la marzocco USA technical bulletin 204

New balance pressure (bypass) valve Linea Micra

February 27th, 2026

Bypass parts in stainless steel	Bypass parts in PPS
bypass valve		
bypass plunger

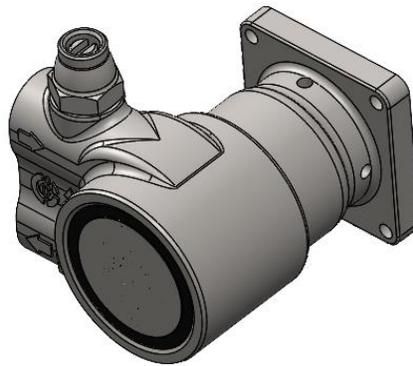
The balance pressure (bypass) component of pump E.3.031.01 installed on the LINEA MICRA has been updated. The material has been changed from stainless steel to PPS.

As a result of this modification, the pump code has been updated from E.3.031.01 to E.3.031.02.

New catalog code for the updated pump is **E.3.031.02**
